**Re: Parking Justification Addendum Letter
Proposed Residential Redevelopment 15, 21, and 27 Shore Street, Town of
Caledon (Bolton), Peel Region
Town File No.: POPA 2024-0007 & RZ 2024-0024**

This parking justification responds to comments from the Town of Caledon. The comments concern the proposed 27-space parking supply for the 19-unit residential development at 15-27 Shore Street. Our analysis addresses the specific items from the Town's August 5, 2025 correspondence. These items include ITE data support, comparative municipal standards, rationale for the parking reduction, a zoning comparison, and Transportation Demand Management (TDM) measures.

Multifamily Housing - 1 BR (Low-Rise) - Not Close to Rail Transit (217) [Click for Description and Data Plots](#)

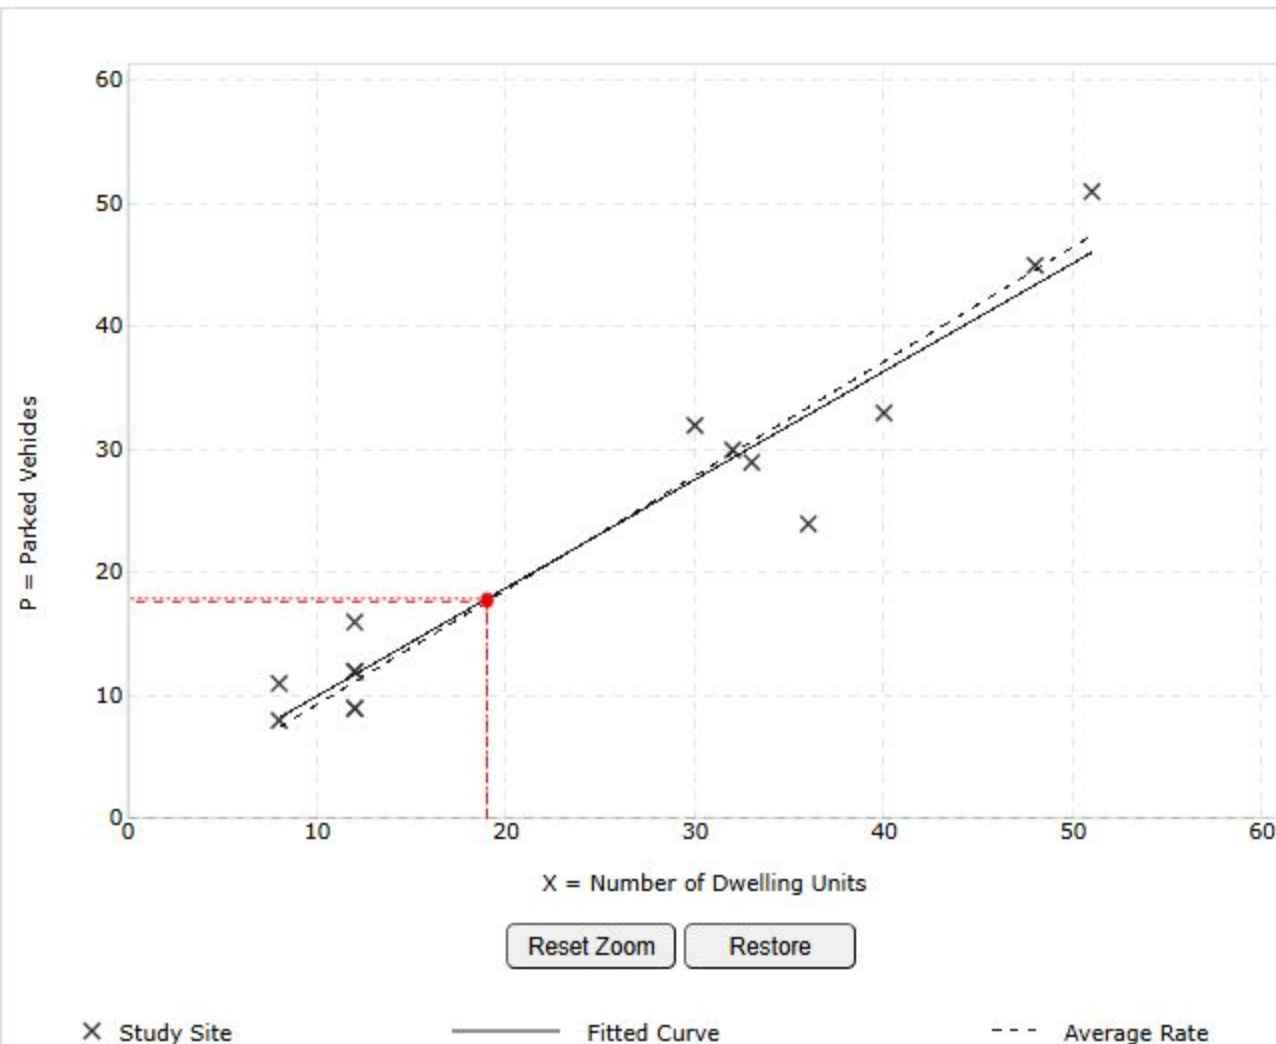
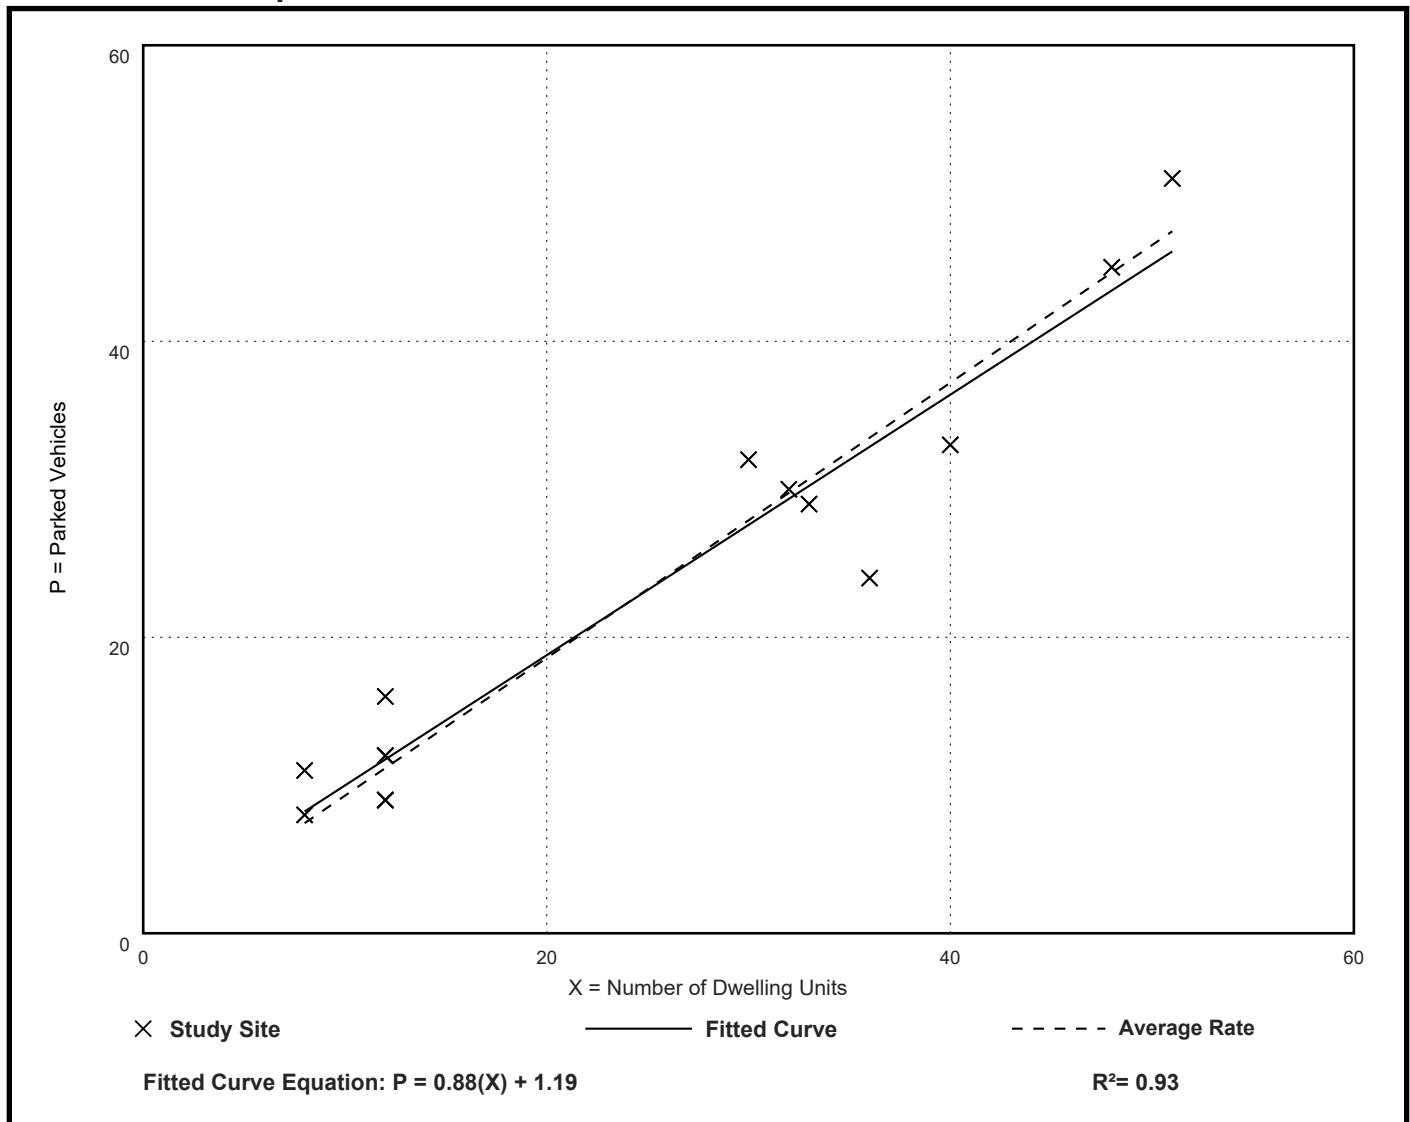
Comment: The proposed rate should be supported by ITE data, with documentation demonstrating its applicability to the number and type of residential units. This requires inclusion of relevant land use code definitions and data charts, considering standard deviation, R^2 , and likely worst-case scenario.

- No R² value, standard deviation, or fitted curve equation is provided.
- **217 dataset (Low-Rise):** See Appendix A for ITE extract for LUC 217.
 - Dataset includes 14 studies, offering a more robust and statistically credible basis for analysis.

- Strong correlation between dwelling units and parked vehicles (R² = 0.93), indicating high predictive reliability.
 - Low variability (Coefficient of Variation = 17%) reduces uncertainty in projections.

- Provides a fitted curve equation: $P = 0.88(X) + 1.19$, enabling site-specific application rather than relying solely on averages
- **Applicability:**

Based on the most conservative measure (85th percentile rate of 1.12 spaces/unit), the projected parking demand for the proposed development is 24 spaces. The proposed supply of 27 spaces exceeds this benchmark, providing a surplus that further ensures adequacy even under peak demand conditions.
